ADDITION TO WYNNFIELD SUBDIVISION, UNIT 5

APPLICATION NUMBER 4 DATE February 16, 2022
 APPLICANT Addition to Wynnfield Subdivision, Unit 5
 REQUEST Subdivision

DETAIL SITE PLAN

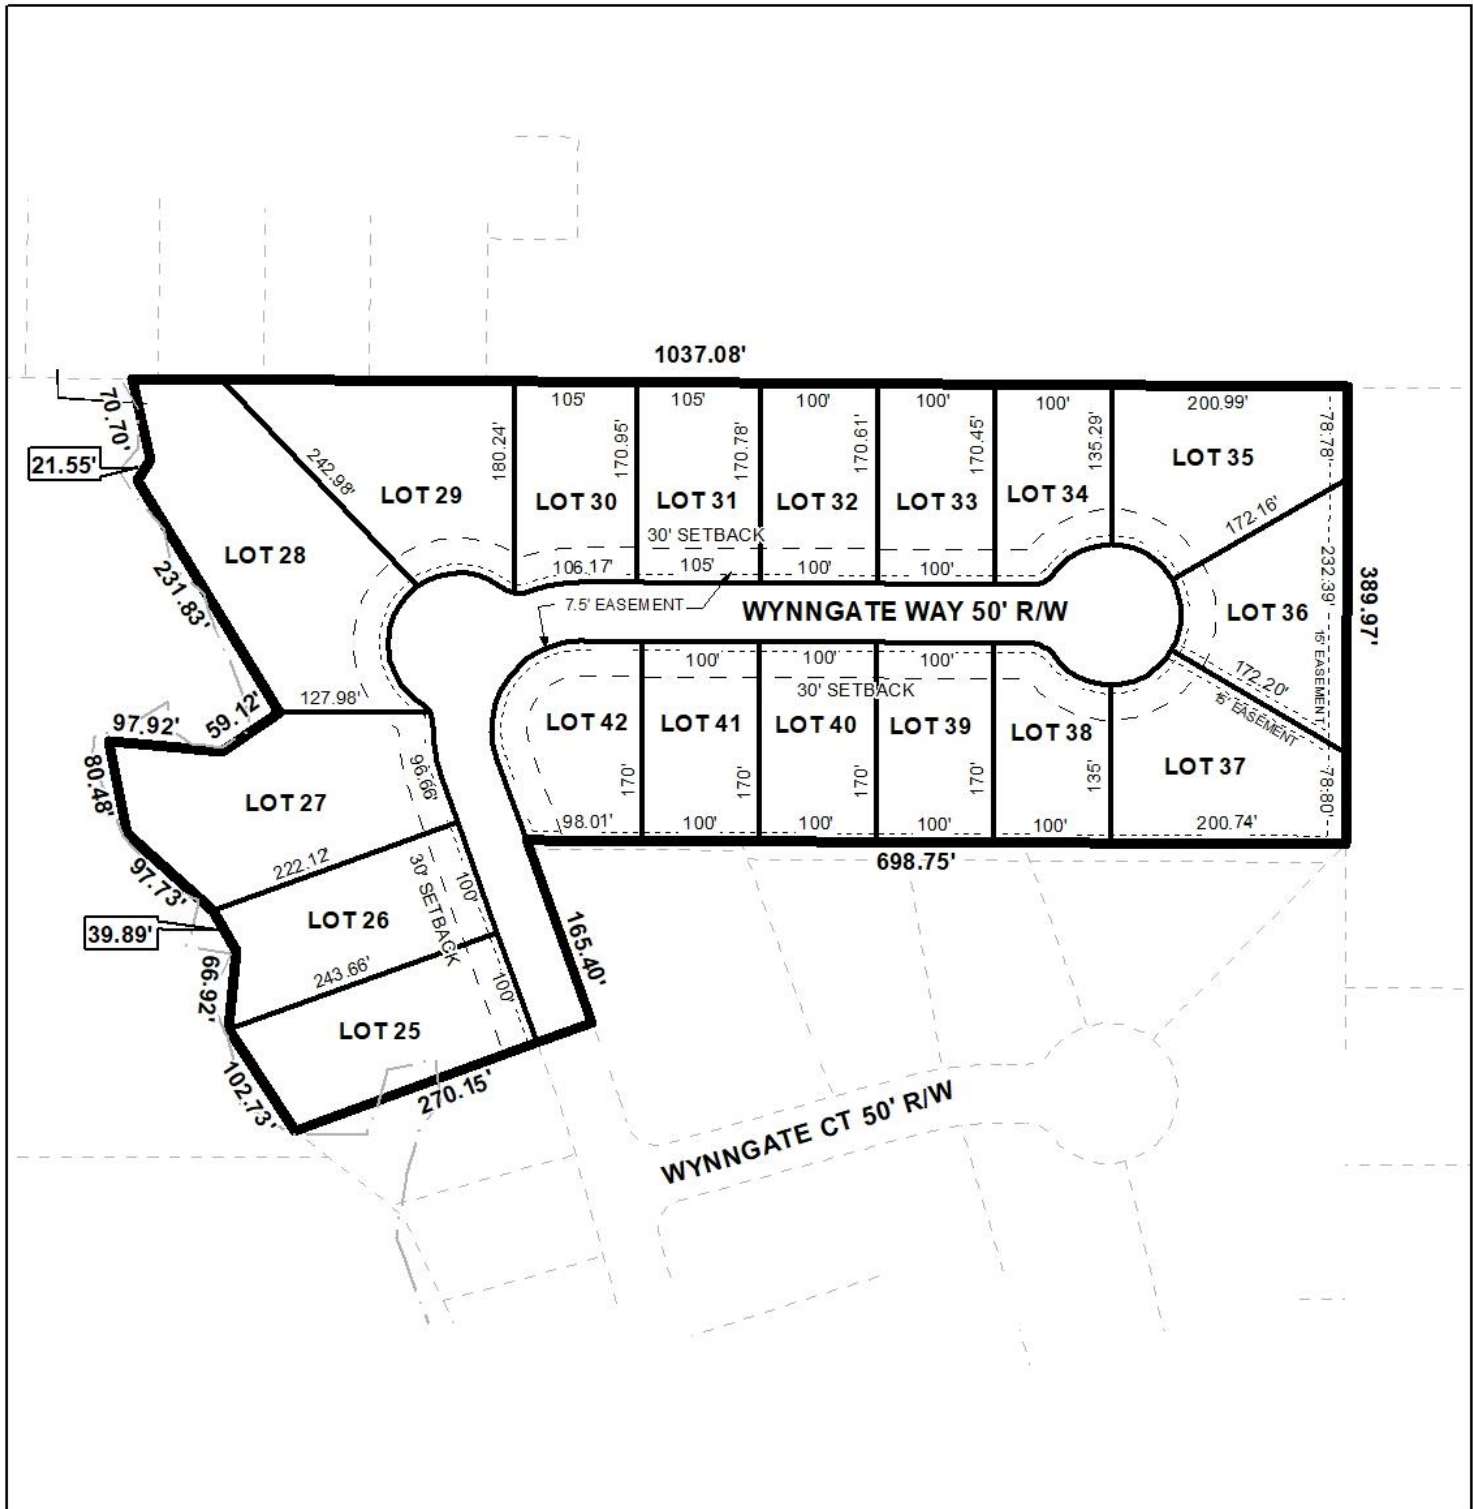
- B. Provide the Surveyor's and Owner's (notarized) signatures.
- C. Delete the 7.5 foot wide Public Drainage Easement from the front of all lots except LOT 38.

- D. Delete NOTE #17 about a 7.5 foot wide Public Drainage Easement.
- E. NOTES #11 – 13 contain blanks that need to be completed.
- F. The drainage easement from Wynngate Way along the northeast and east property of LOT 37 shall be labeled as PUBLIC and shall have a different line type than the Private Drainage Easements. Any other drainage easement shall be labeled PRIVATE. Coordinate with the Engineering Department as needed after construction is complete to finalize the PUBLIC Drainage Easements.

Proposed streets are labeled to have compliant 50' rights-of-way, and the cul-de-sac at the East terminus of Wynngate Way is indicated to have a compliant 120-foot diameter. The right-of-way width label for all streets should be retained on the Final Plat. All lots are indicated to have a compliant 30-foot minimum building setback from the street frontages, and this should be retained on the Final Plat. All lots are labeled with their sizes in both square feet and acres, meeting the minimum standards of the Subdivision Regulations, and the lot size labels in both square feet and acres should be retained on the Final Plat, or a table should be furnished on the Final Plat providing the same information.

The preliminary plat indicates that all lots will have a 7.5-foot drainage and utility easement along the front of each lot, and various other drainage and utility easements along the South and East boundaries of the subdivision. A note on the preliminary plat states that no structures shall be placed or erected within any easement. This note should be revised to state that no structures shall be constructed or placed within any easement without permission of the easement holder.

The preliminary plat does not include the entire area of the parent parcel R023303072000036.000. Therefore, the plat should be revised to include the entire Parcel R023303072000036.000, with areas not included in proposed development to be labeled as Common Area or Future Development. If shown as Common Area, a note should be required on the Final Plat stating that the maintenance of all Common Areas is the responsibility of the property owners.

- 1) retention of the right-of-way width label for all streets on the Final Plat;
- 2) retention of the 30-foot minimum building setback line along all street frontages on the Final Plat;

- 3) retention of the lot size labels in both square feet and acres, or the furnishing of a table on the Final Plat providing the same information;
- 4) revision of Note #9 on the Final Plat to state that no structures shall be constructed or placed within any easement without permission of the easement holder;

- 5) revision of the plat to include all of Parcel R023303072000036.000 on the Final Plat;
- 6) revision of the plat to label all areas of Parcel R023303072000036.000 as Common Area or Future Development which are not included in the development;
